Access Compliance Report

Public Rights-of-Way

Intersection ID: 26308	Main Street: WEDDINGTON_RD	Cross Street: MCKEE_RD	Location: NW
ADA ID: 0260B583B373	Ramp Type: PerpDiag	Initial Pass/Fail: Fail	Overall Compliance: No
		Severity Score: 10

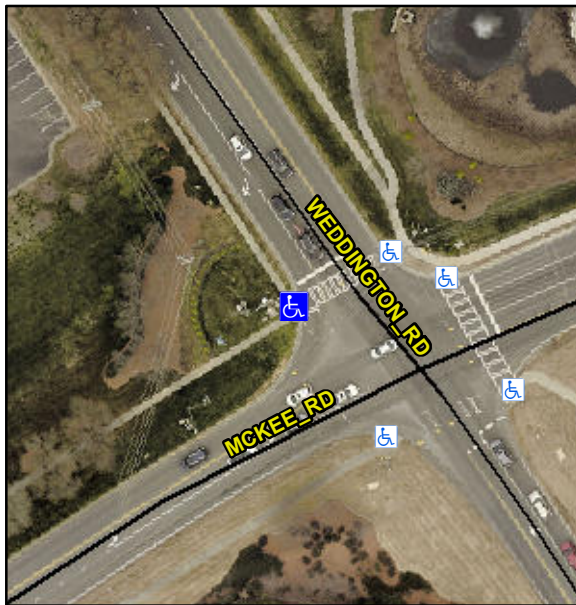
Not Found, R304.5.1, R304.5.3

Compliance	Description	Data	Compliance	Description	Data
N/A	Ramp Length (in)	67.0	Yes	Ramp Slope (%)	5.3
No	Ramp Width (in)	47.0	No	Ramp XSlope (%)	2.3
N/A	Flare Type LT	N/A	N/A	Flare Type RT	N/A
N/A	Flare Slope LT (%)	N/A	N/A	Flare Slope RT (%)	N/A
N/A	Flare Traversable LT?	N/A	N/A	Flare Traversable RT?	N/A
N/A	Landing Length (in)	N/A	N/A	DWS Provided?	N/A
N/A	Landing Width (in)	N/A	N/A	DWS Contrast?	N/A
N/A	Landing Slope (%)	N/A	N/A	DWS Length (in)	N/A
N/A	Landing X Slope (%)	N/A	N/A	DWS Full Width?	N/A
N/A	Landing Curb? (Y/N)	N/A	N/A	DWS Offset (in)	N/A
N/A	Shared Landing?	N/A			
N/A	Gutter Ponding?	N/A	N/A	Gutter Slope (%)	N/A
N/A	Gutter Lip Ht (in)	N/A	N/A	Gutter X Slope (%)	N/A
N/A	Painted X Walk1?	Yes	N/A	Painted X Walk2?	Yes
	X Walk 1 Direction	To S		X Walk 2 Direction	To E
N/A	X Walk 1 Width (in)	107.0	N/A	X Walk 2 Width (in)	107.0
	X Walk 1 Slope (%)	0.2		X Walk 2 Slope (%)	1.1
	X Walk 1 X Slope (%)	2.2		X Walk 2 X Slope (%)	0.5

Remove & Replace Curb Ramp With Two New Directional Ramps or Equivalent.
